Comments from Transport Department (TD)

S.16 Application No. A/NE-LYT/846

附圖A

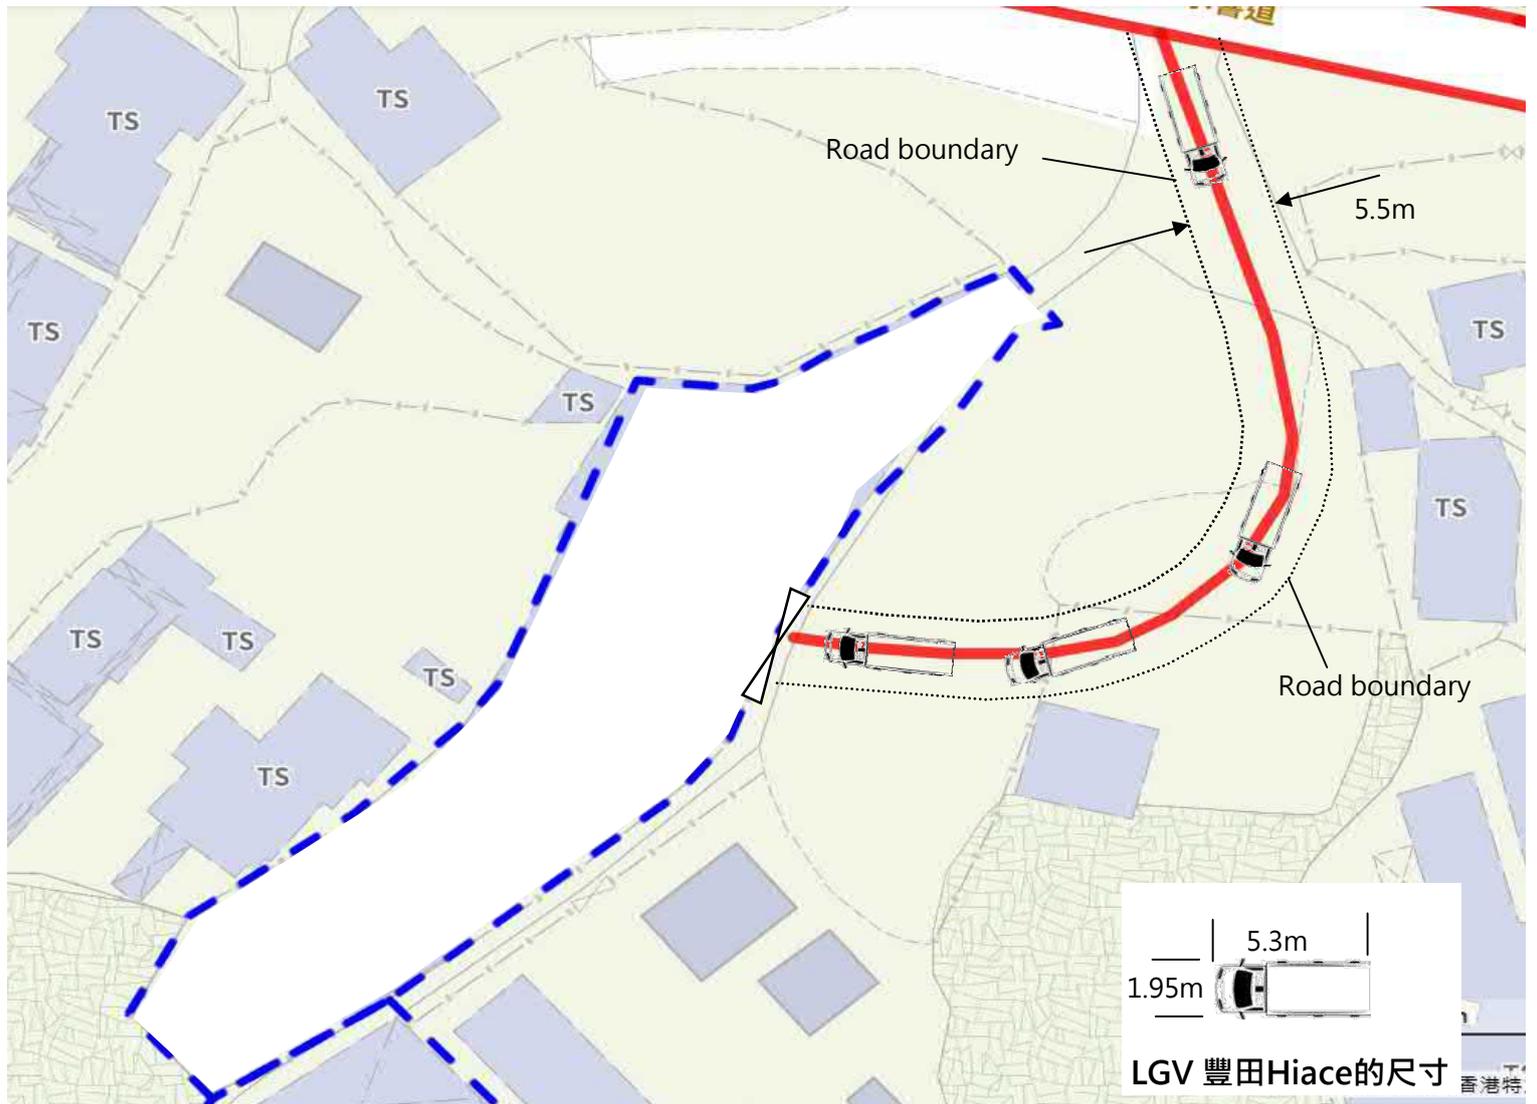
1. According to a recent aerial photo, the structure in Land Lot No. 390B in D.D. 85 still exists. The applicant should clarify whether the access road will be diverted to avoid encroaching this structure.

由於先前設計入車路段有些圖面上的落差，經運輸署的糾正，現在申請人將有關的錯誤糾正，以便車輛順暢進出申請場地（請見附圖A）
